Concept Approval

Application No.:	MP10_0165
Proponent:	EGC Custodian Services Pty Ltd
Approval Authority:	Minister for Planning and Infrastructure
Land:	Lot 6 DP 260000, Lot 3 DP 25688 & Lot 4 DP DP25688 5 Whiteside Street and 14 & 16 David Avenue, North Ryde
Project as approved:	Residential flat development concept, including: <ul style="list-style-type: none">• use of the site for residential flat buildings;• indicative building envelopes for 4 buildings to a maximum height of RL 78.6;• Limiting the maximum yield to 135 units;• Two split basement levels of car parking;• Road works and site access arrangements to support the development; and• Landscaping and associated works.

SCHEDULE 2

Figure 1: Revised Building Envelope - Building A

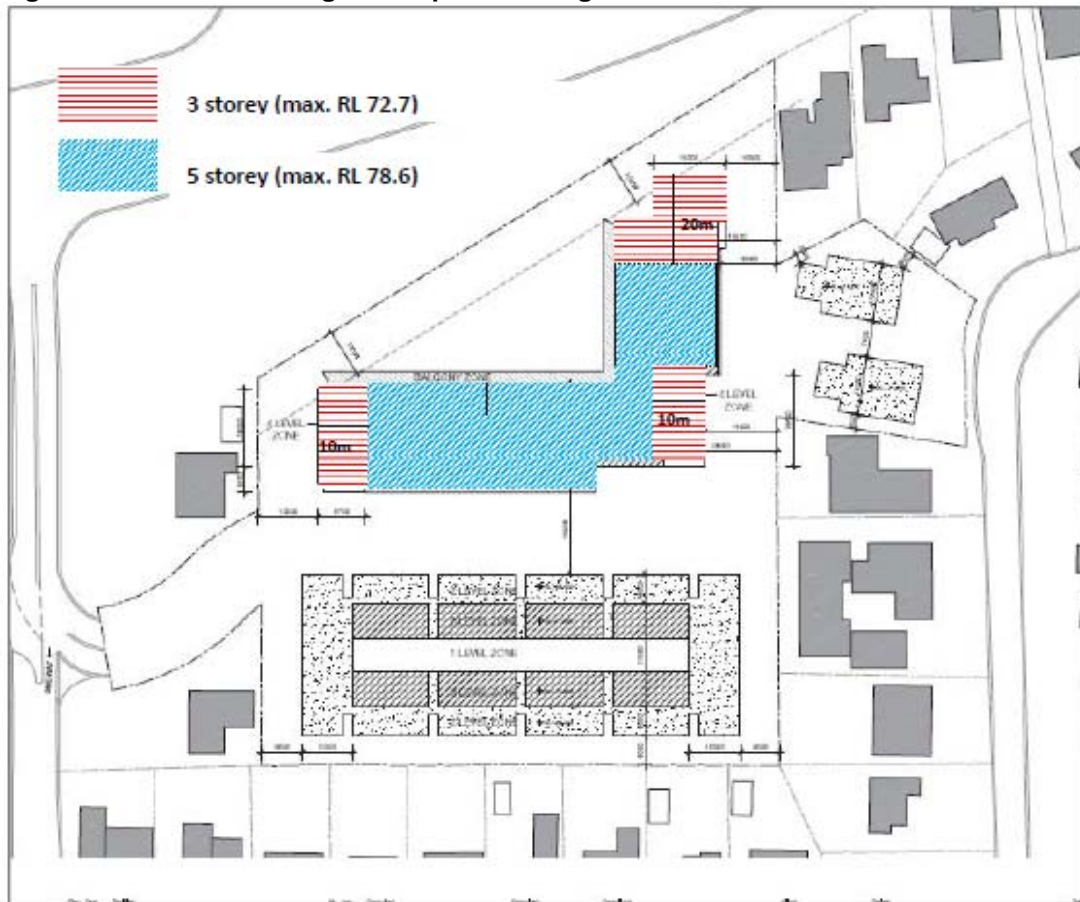
The building heights shown on 'Envelope Plan' DA-04 prepared by SJB Architects and referred to in condition A2 shall be modified as follows:

- a) the building envelope for Building A (fronting Epping Road) shall be reduced to 3 and 5 storeys (maximum RLs 72.2 and 78.6, respectively) as illustrated in **Figure 1** below, excluding any plant, lift overruns, or similar projections). Drawings indicating heights to AHD shall be provided with the future application/s.
